Sheet: /fpga/adc/
File: adc.kicad_sch

Sheet: /power/ File: power.kicad_sch		
Title:		
Size: A4	Date:	Rev:
KiCad E.D.A. 9.0.7		Id: 5/12

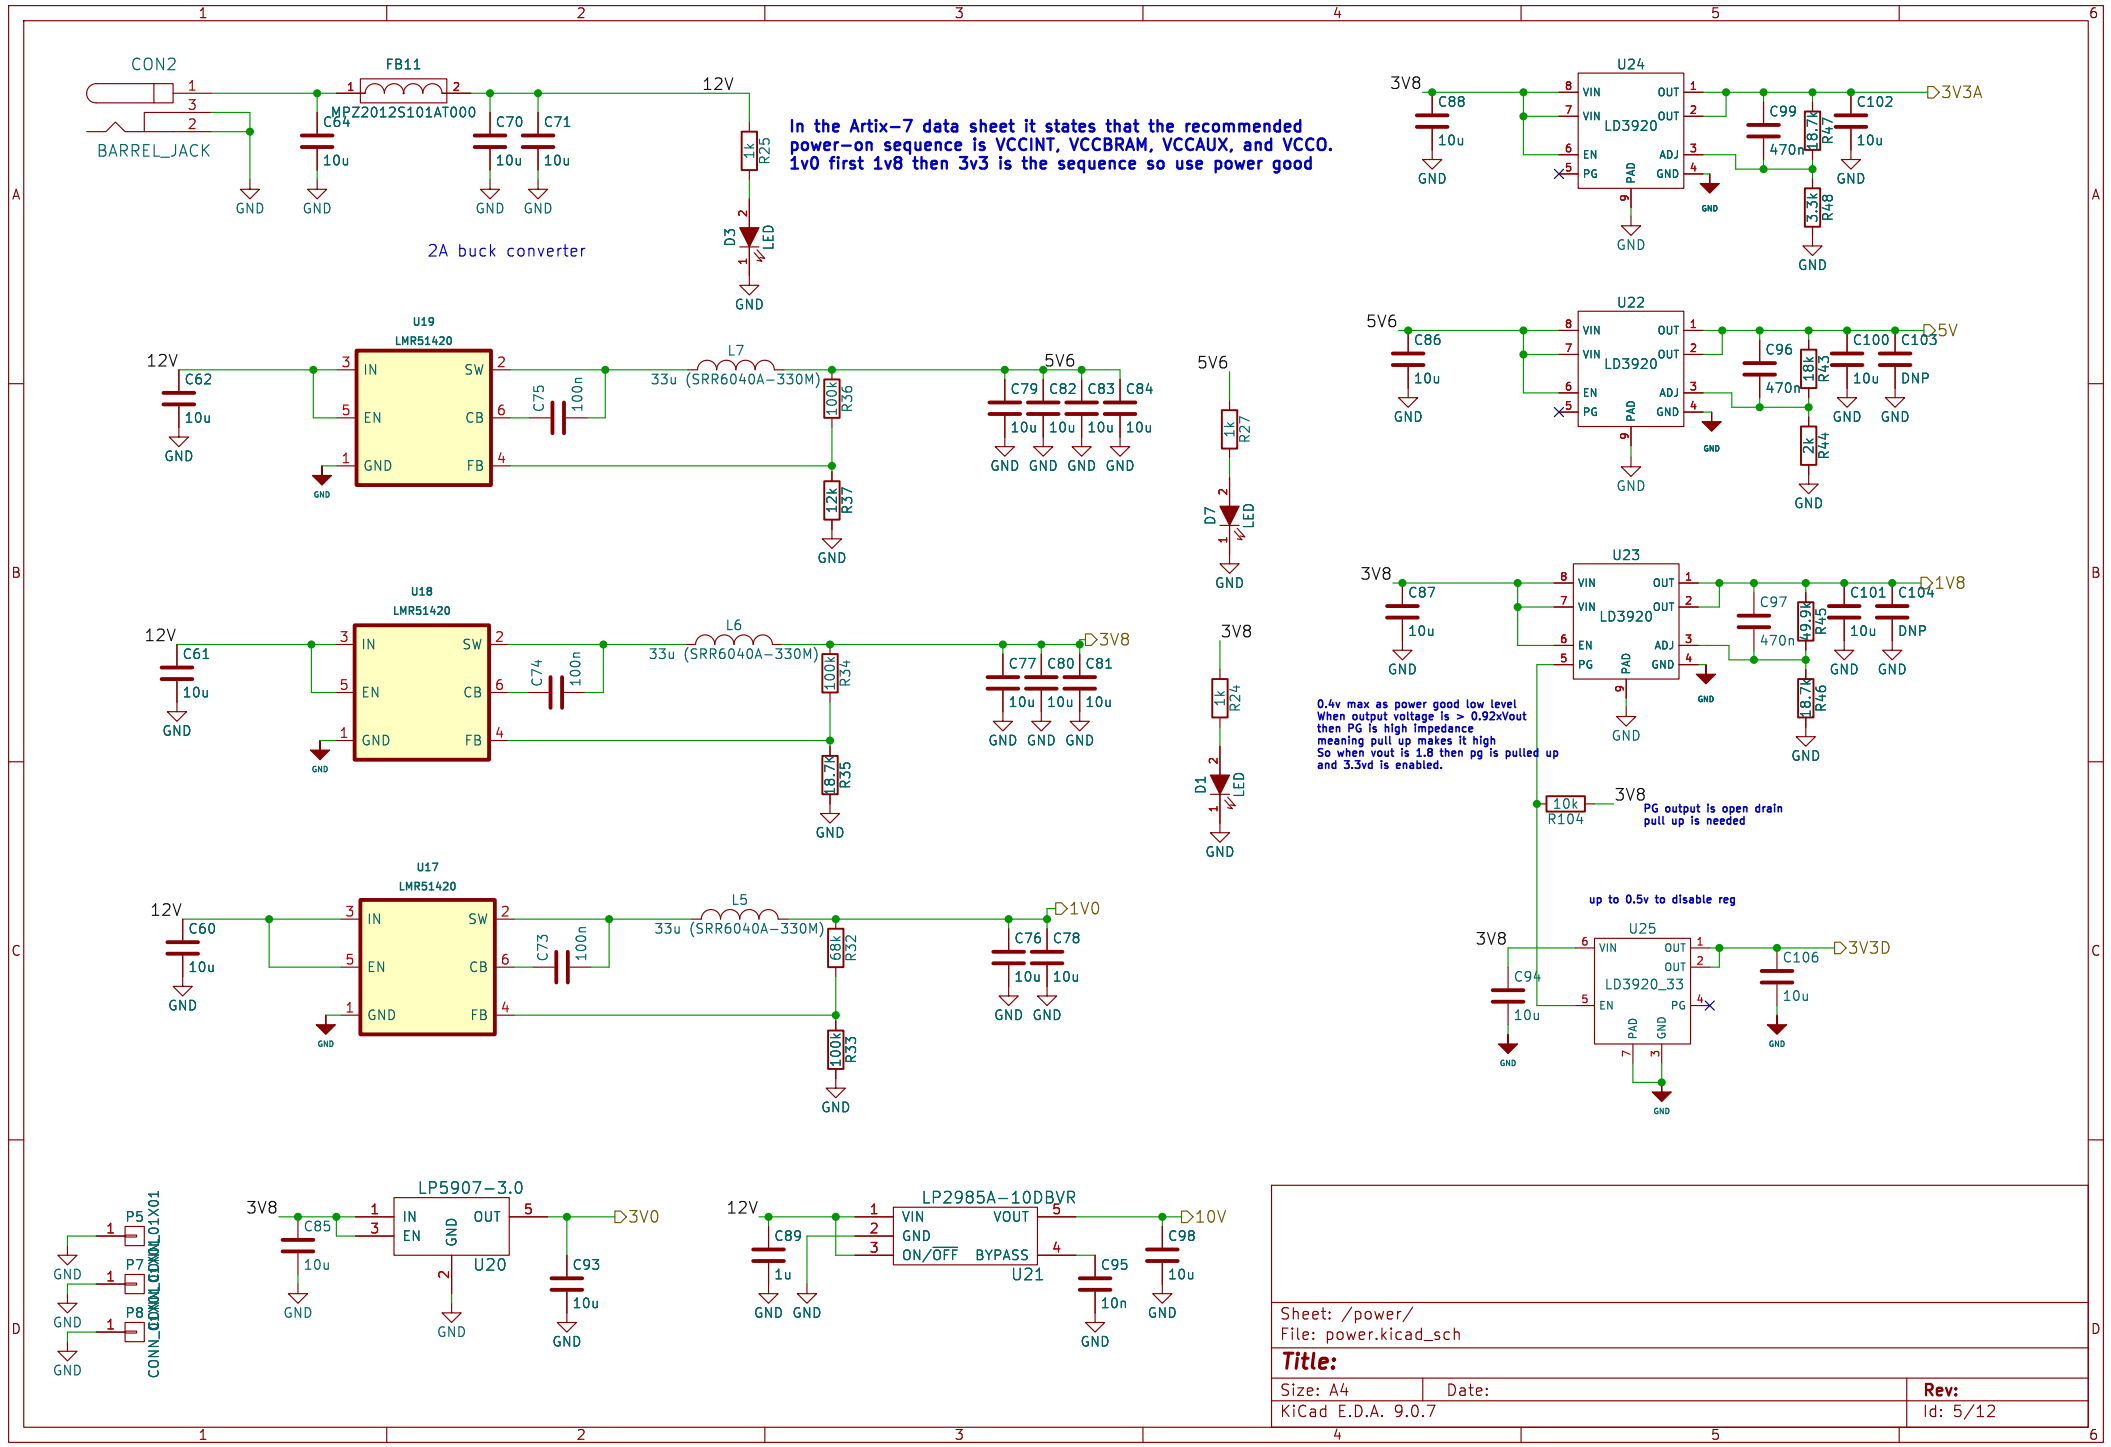
In the Artix-7 data sheet it states that the recommended power-on sequence is VCCINT, VCCBRAM, VCCAUX, and VCCO. 1v0 first 1v8 then 3v3 is the sequence so use power good

0.4v max as power good low level
When output voltage is > 0.92xVout
then PG is high impedance
meaning pull up makes it high
So when vout is 1.8 then pg is pulled up
and 3.3v is enabled.

PG output is open drain
pull up is needed

up to 0.5v to disable reg

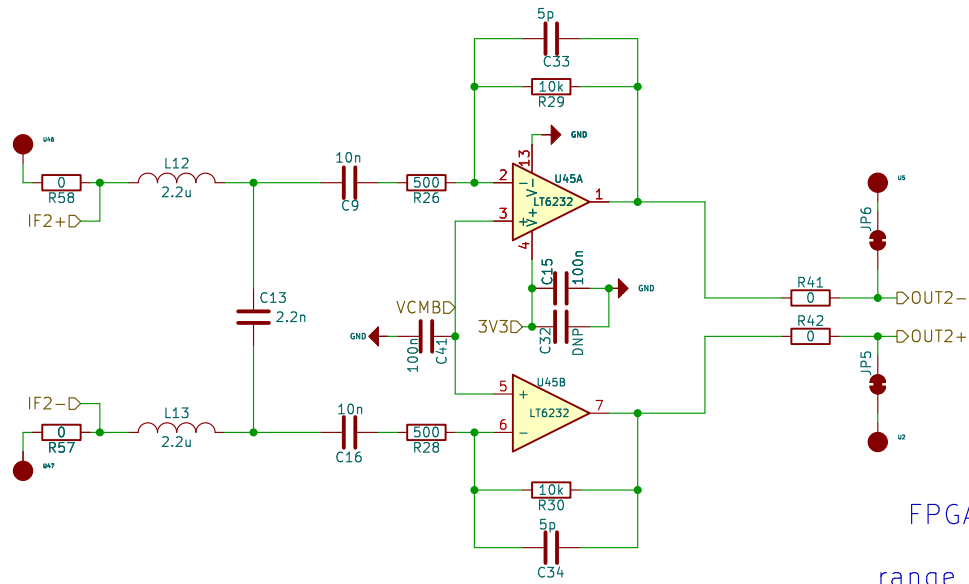
FPGA FIR Filter works perfectly.
Second stage for HPF
range compensation filter is removed

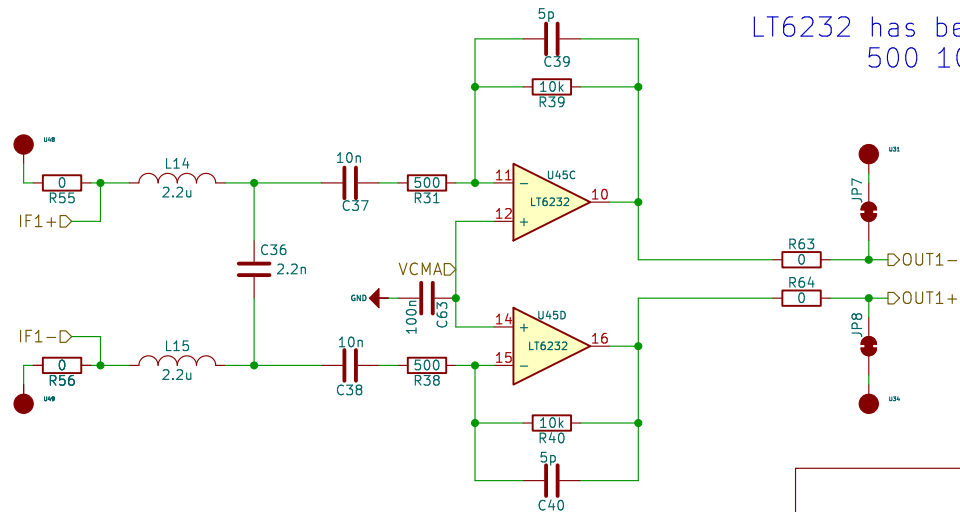
LT6232 has better noise performance as $1.1\text{nV}/\sqrt{\text{Hz}}$
500 10K has less noise contribution

Sheet: /clock/
File: clock.kicad_sch

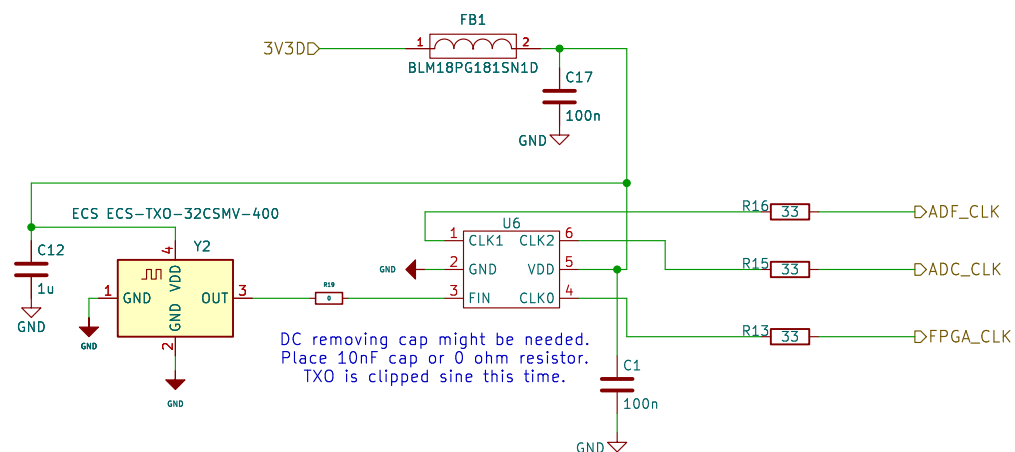
This is the prev design:
NB3N551 is obs.
Also this txo is generating pure sin.
ADC might need cmos like input not sin.
That could be the reason of duty stabilizer.
